SSD 5752, Sydney International Convention, Exhibition and Entertainment Precinct – Redevelopment of convention centre, exhibition centre, entertainment facilities and associated public domain works (SSD) is referred to as **PPP**

Sydney International Convention, Exhibition and Entertainment Centre Precinct – Mixed use Development in the Southern Haymarket Precinct (Concept Proposal) (SSD) is referred to as **PDA**

## ERRORS OF COMMISSION AND OMISSION IN PUBLIC DOCUMENTS

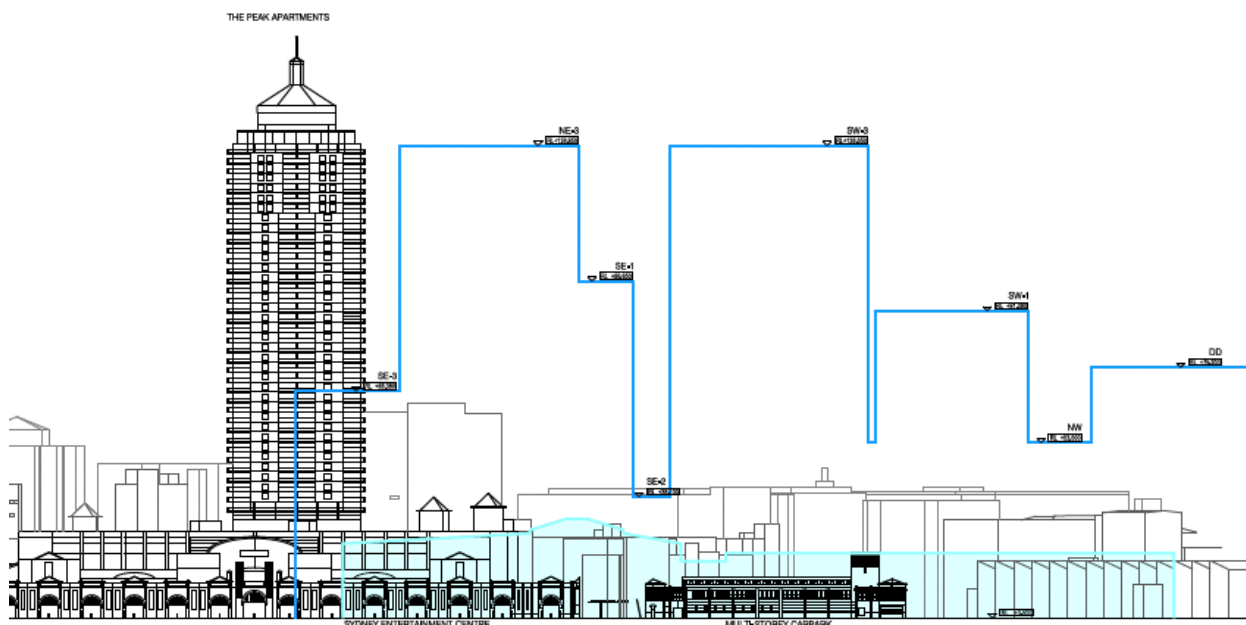
Is the site area **43,880m<sup>2</sup>** or **47,530m<sup>2</sup>** ? Whichever figure is used, neither equates to an FSR of 4.3:1

The real area between Hay Street, Pier Street, Harbour Street and Darling Drive is in fact nearer to **30,000m<sup>2</sup>**.

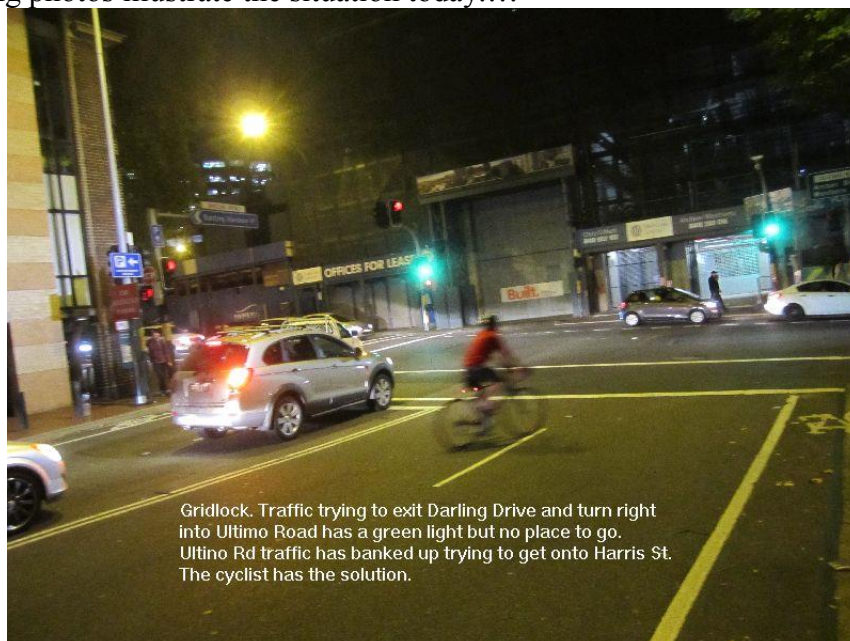
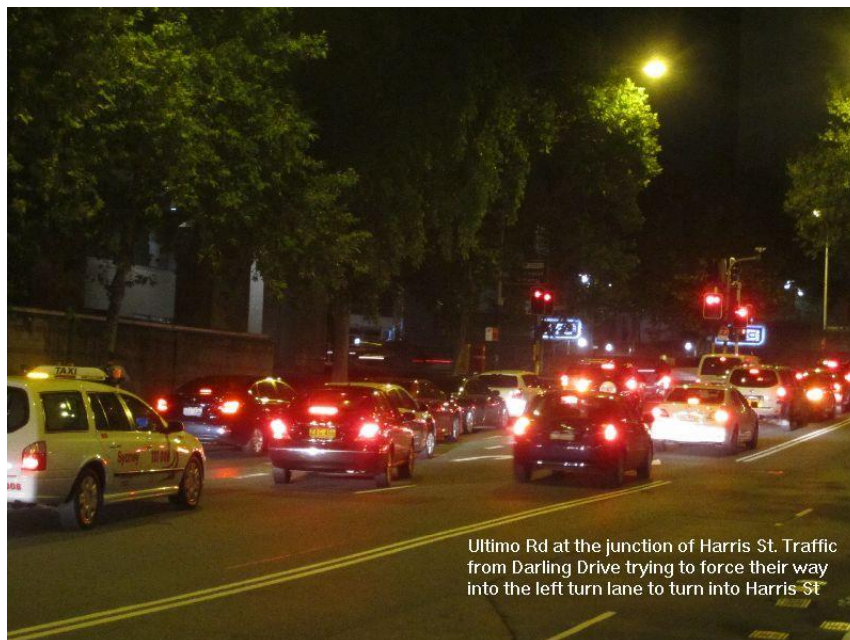
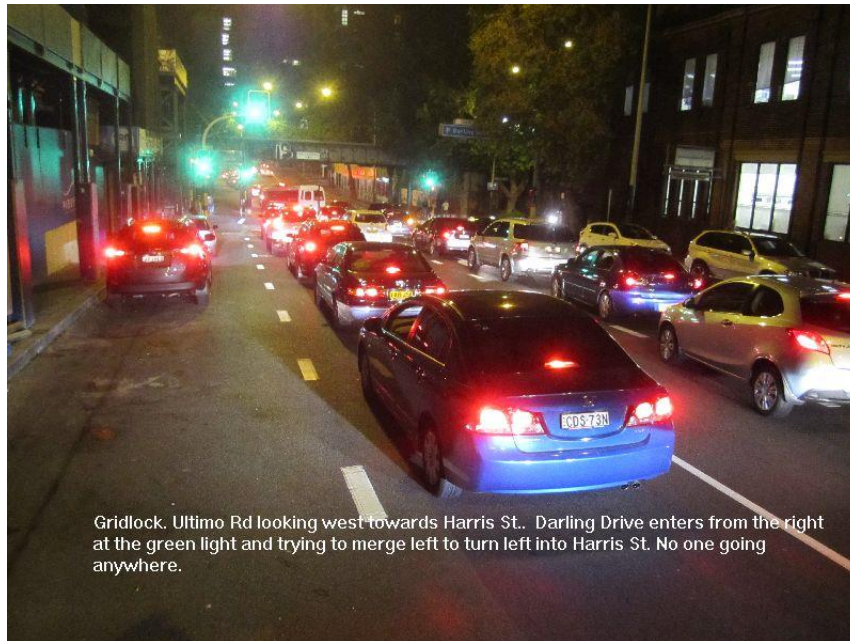
This illustrates how Ultimo Road is key. Westbound it is already very congested at its junction with Harris Street, where most vehicles wish to turn left onto Harris Street.

Vehicles turning right from Darling Drive into Ultimo Road, with the intention of turning left onto Harris Street have no option but to turn into the RH lane (as if to turn right onto Harris Street) and then push into the left hand lane across the cycle path. This is the only way to get 4-6 cars, per traffic light cycle, from Darling Drive onto Ultimo Road. When Darling Drive is fully utilised under the new development, there will be LoS E (unacceptable) condition at the junction with Ultimo Road.

The following photos illustrate the situation today....

### 5. Increased motor and pedestrian traffic on Darling Drive

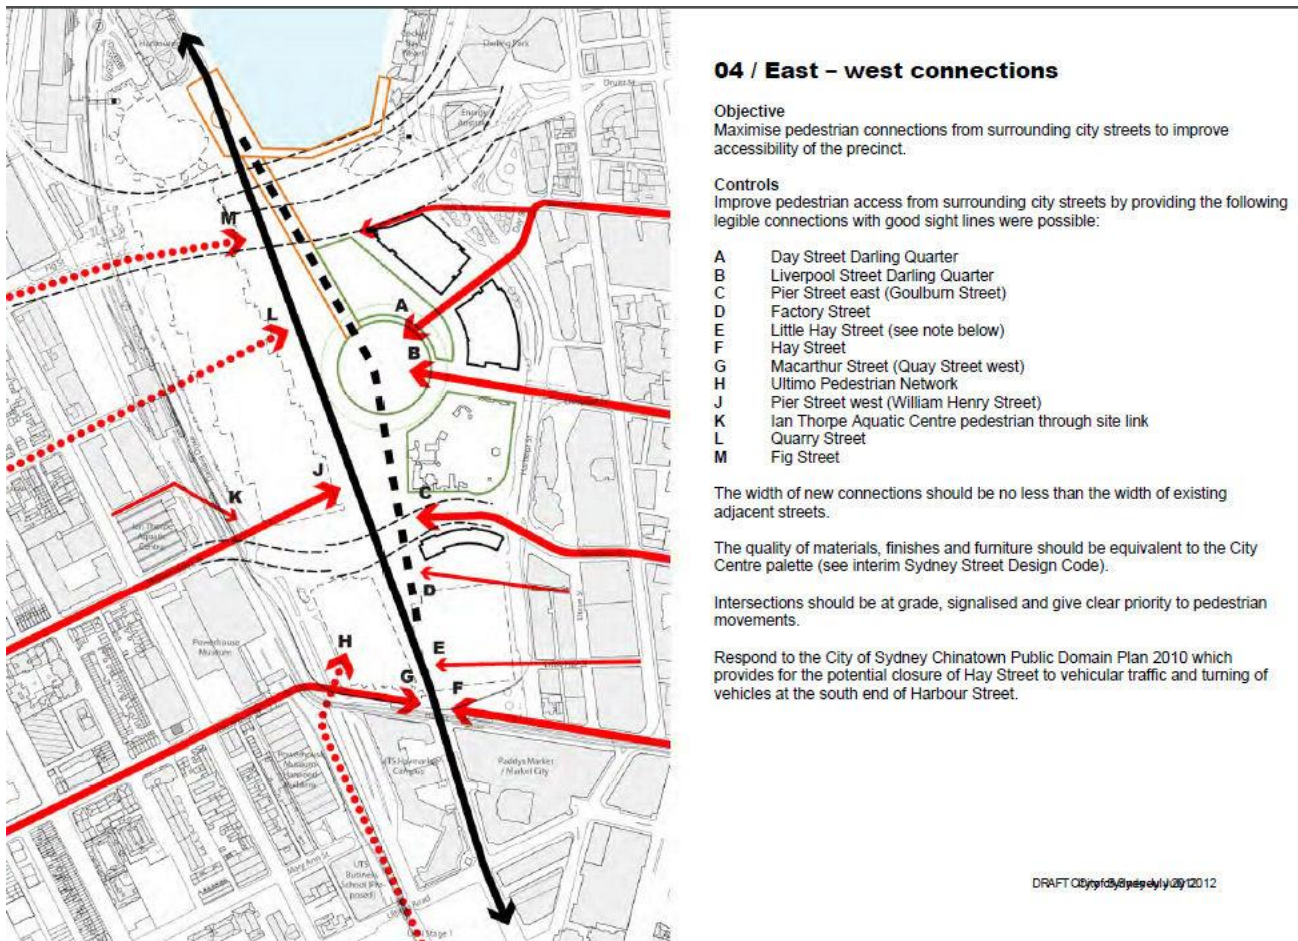
The proposed move of the Entertainment Centre to Darling Drive, the building of 2 student accommodation blocks and a 900 bed hotel, along with the increase in size of the Exhibition and

Convention Centres will inevitably increase the traffic and the number of pedestrians using and crossing Darling Drive. For example:

- pedestrians leaving the Darling Harbour theatre/exhibition/convention will cross Darling Drive to get to the Goods Line, as it will be the easiest route to Central Station and more sheltered in bad weather.

- every 6 minutes, passengers using the light railway to/from Darling Harbour will cross Darling Drive. (DHL advise that the new light rail schedule will be increased to one every 6 minutes when the Dulwich Hill extension is open.)

- students (1000 of them) who live in the 2 student accommodation blocks will naturally take the shortest route to the Haymarket Precinct, Paddy's and Market City - straight across Darling Drive.

- all cars, taxis, buses, coaches and trucks travelling north from Ultimo Street to access the buildings along the eastern side of Darling Drive (hotels, exhibition, convention, entertainment), will all have to cross the oncoming traffic.

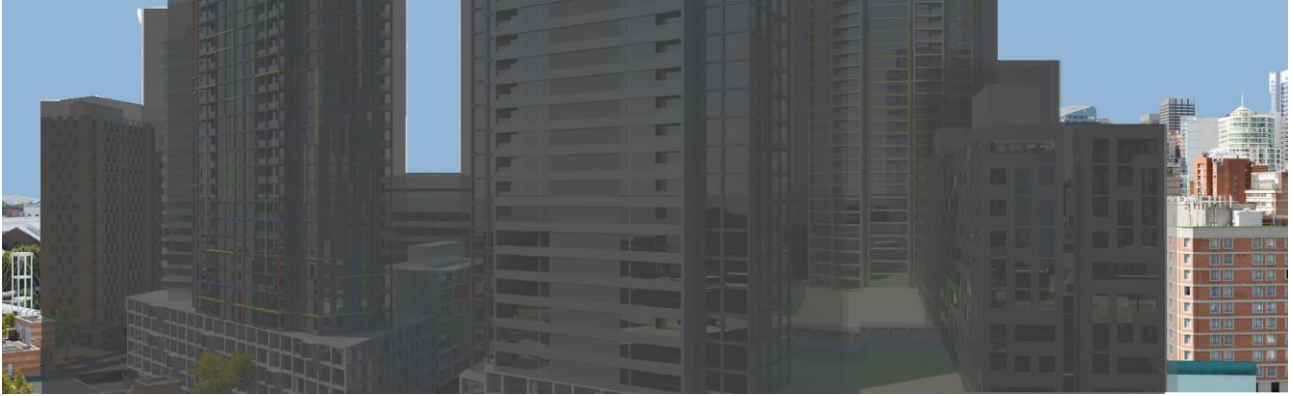
This proposal flouts this practise with no apology and will deprive many people of sunlight as well as their existing pleasant outlook. These photographs illustrate what will happen to the northward views of apartments in The Peak at lower, mid and higher levels.

Today people on the lower floors of The Peak see this...

If the proposed Haymarket Precinct building goes ahead they will get this ...
